**Colne Valley Park
Community Interest Company**

Response to

Heathrow Airport Consultation

September 2019

Figure 6.11.4: Parameter Plan - Zone K

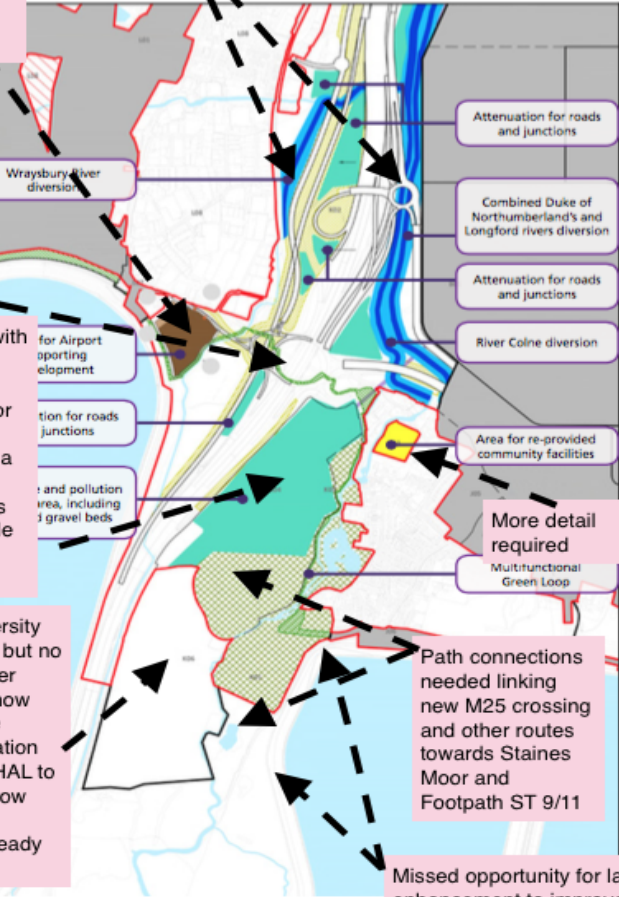
Intrusion of ASD with contrived green loop creating undesirable dog-leg. This development area was not in the original plans and not in the masterplan appended to the Airports NPS. In contrast the area was shown as GI.

Area marked as biodiversity area on illustrative plan but no information on parameter plan. Outside DCO so how will it be delivered? Site already part of a restoration plan so misleading for HAL to imply that this is Heathrow mitigation when enhancements area already provided for.

Loss of N-S New riverside access. New corridors offer no public benefit. Contribution of rivers to character of valley lost.

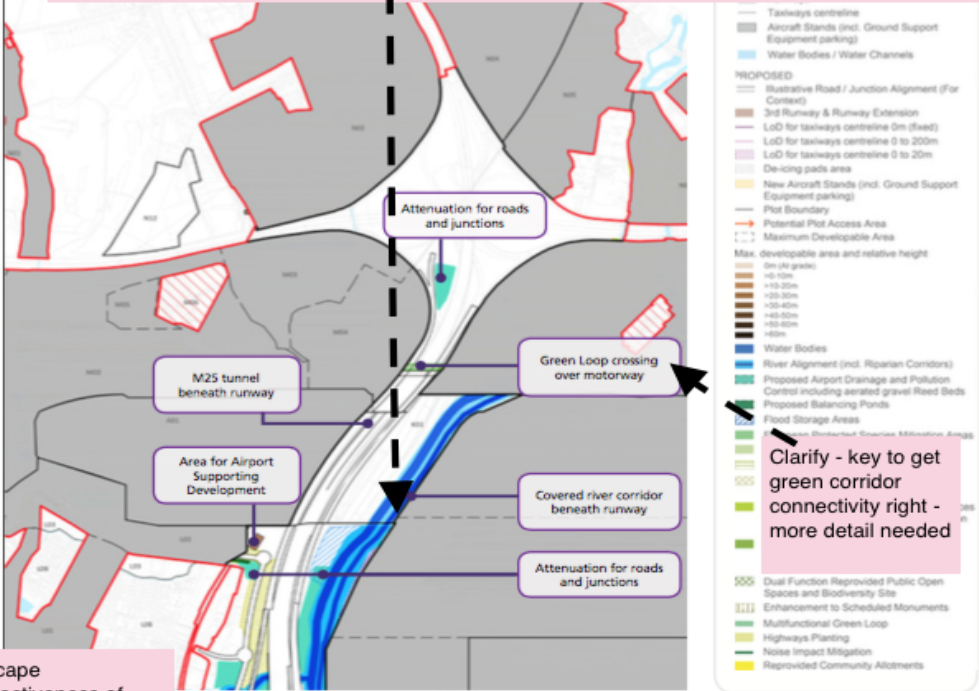
Note: The comments below apply to the extent of the CRC

- The covered river corridor is an unproven concept with no legal requirement to maintain to the standard it was created. Insufficient evidence has been provided by Heathrow to demonstrate that this scheme is viable.

- Due to the merged river corridor's proximity to the runway, protected species will be significantly impacted by land take, changes in hydrology, fragmentation of habitats, noise and vibration, and light intensity.

- The merged river channels follow an artificially straightened course so are unlikely to provide natural geomorphology, flow types or habitat.
- If the Colne and Wraysbury's bed is lined they will lose groundwater connectivity, effecting flow and water quality downstream. This area may require lining if land is contaminated.

Figure 6.12.5: Illustrative 3D massing - Zone L - Industrial Development Area

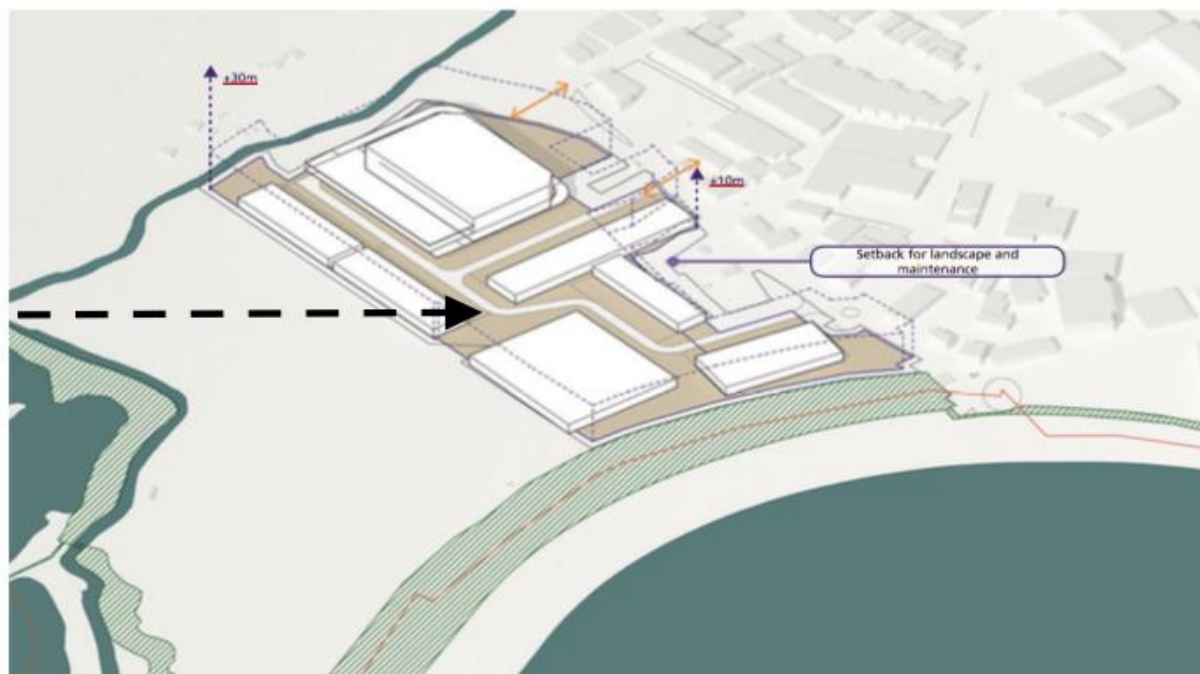
This expansion has a major impact on the CVRP and a narrow, sensitive section of GB. The CVRP objects to the principle. This was not in the original plans and not in the masterplan appended to the Airports NPS. In contrast the area was shown as GI.

If, nevertheless, the case for expansion is accepted at DCO stage the development parameters should provide for greater mitigation than indicated to address impacts. This should be discussed prior to submission and, as a minimum, incorporate:

- Bringing the land to the west of this site forward as GI mitigation, into positive management for landscaping, people and wildlife as part of a whole zone edge to edge plan.
- A central E-W green spine providing a visual connection with the open green land beyond and active travel connectivity to it (and forming part of the wider active travel network - see Joint Connectivity Statement). This green spine can serve to improve the context/ setting for listed Poyle Farmhouse.
- Improve the relationship of southern boundary with Poyle Poplars to provide a green transition & reduced scale of building.
- Improve the relationship of western boundary with the land to the rear/ west to provide a green transition.
- A generally reduced scale of building to better respect the Colne Valley Park/ Green Belt context

Figure 6.13.4: Parameter Plan - Zone M

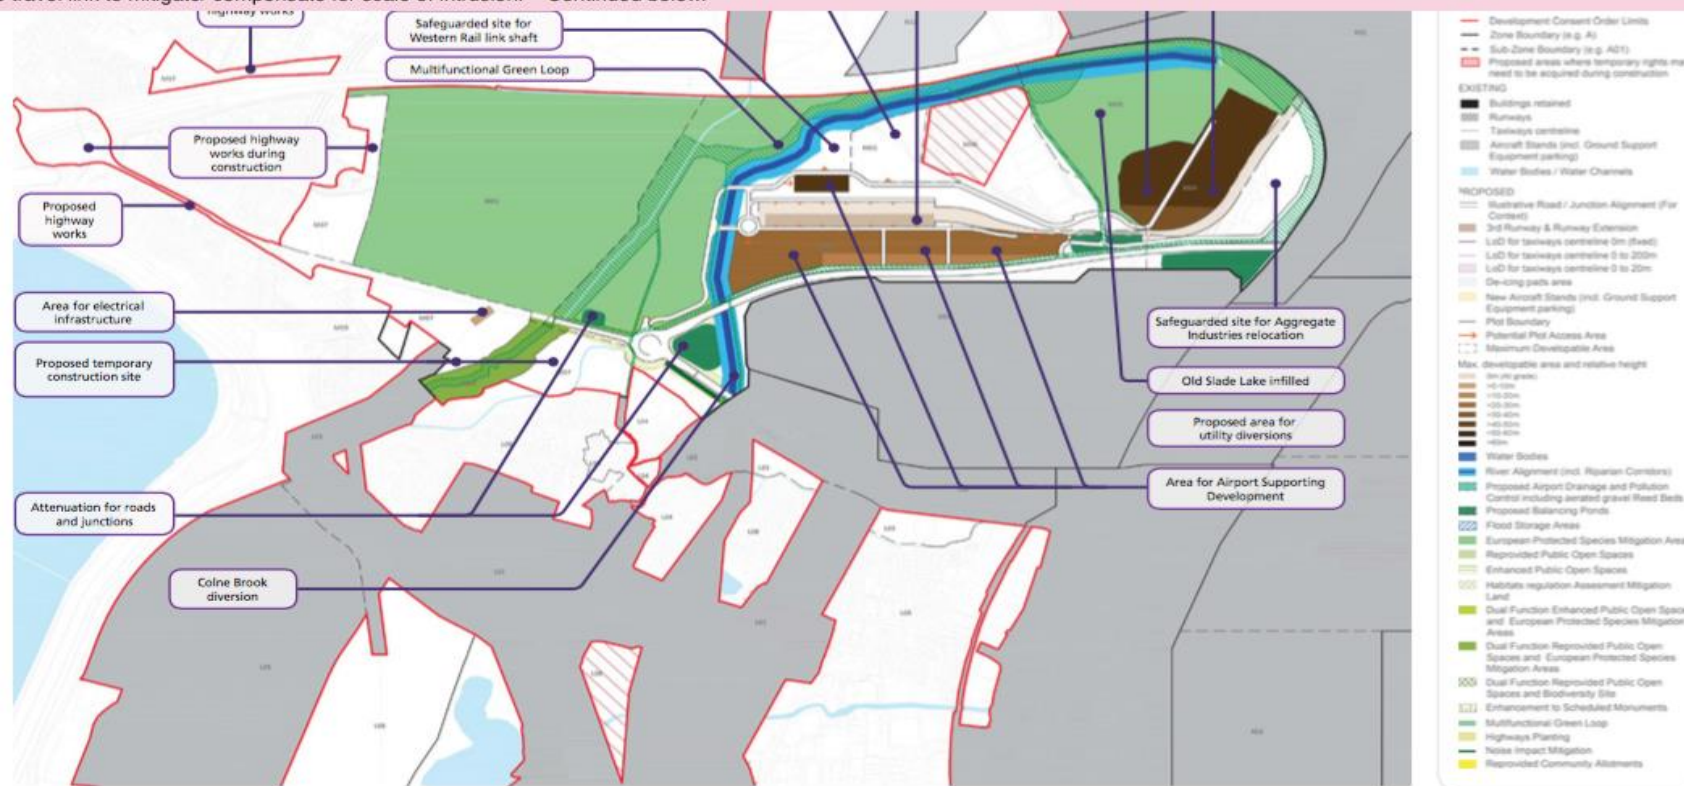
Objection to this extensive development area which was not in the original plans and not in the masterplan appended to the Airports NPS. In contrast the area was shown as overwhelmingly GI. Our objections can be summarised as:

- Very poor corridor for diverted Colne Brook - its course defined by the boundary of the rail head and M4 - width of corridor too narrow and the proximity of the river to the m/way/ rail-head and other development, incl. EFW plant unacceptable. Inadequate landscape and natural context for what will be the only open river channel in the remaining 'green wedge' offering N-S connectivity.

- Old Slade Lake infilling unacceptable - creating EPS mitigation by destroying existing habitat not justified. Also the Old Slade Lake 'infill' provides a green space is the wrong location for such a facility - that will not be attractive as a destination.

- Colnbrook West Lake which feeds the County Ditch is proposed to be filled in. HAL must provide clarity on how flow to the county ditch will be maintained- Inadequate mitigation with no creation of a high quality active travel link to mitigate/ compensate for scale of intrusion. Continued below.
